22463 I-70 Genoa East and West Pavement Reconstruction Project Final Value Engineering Report

Prepared For:
 **COLORADO**
Department of Transportation

Date: January 2020

PROJECT: 22463 I-70 Genoa Pavement Reconstruction Project	Idea No.: 35 Date: July 11 th , 2019
DESCRIPTION OF IDEA: Use precast concrete panels for mainline at ramps	Page No.: 2 of 4

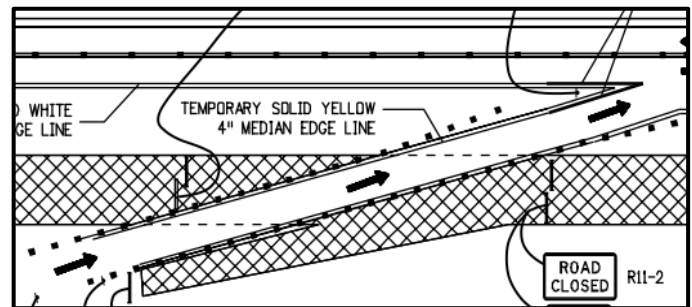
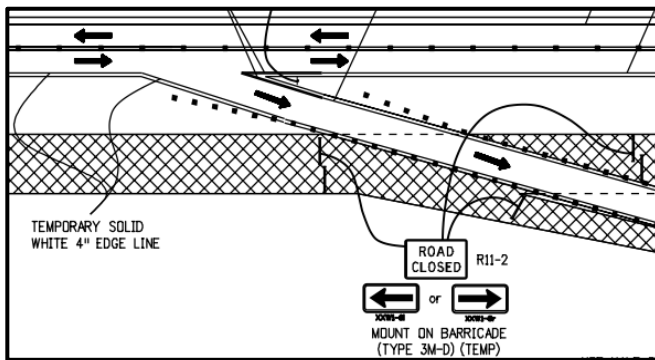
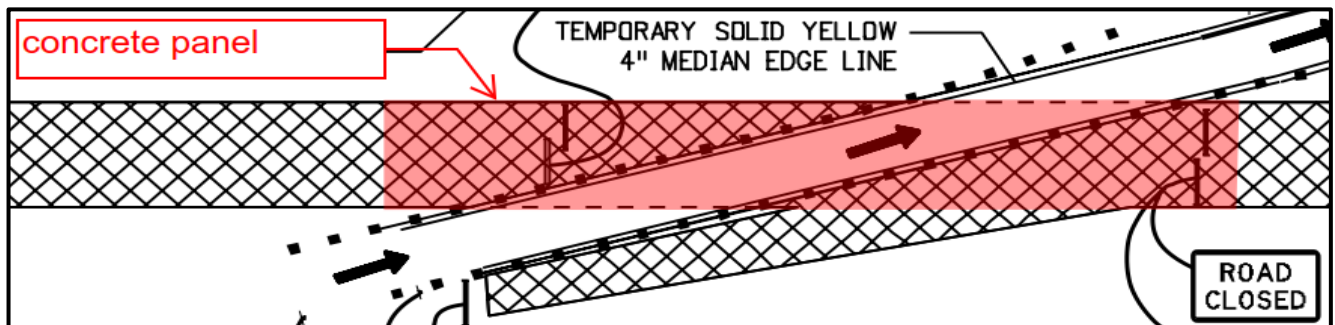
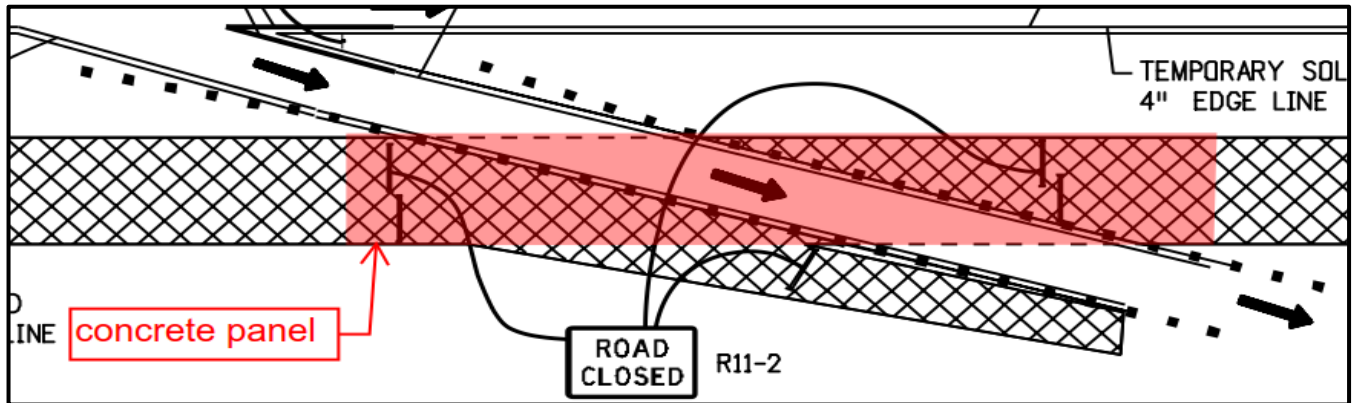
Construction Costs
Base Case Design	\$992,199
Proposed Design	\$7.44M
Estimated Additional Costs	\$6.48M
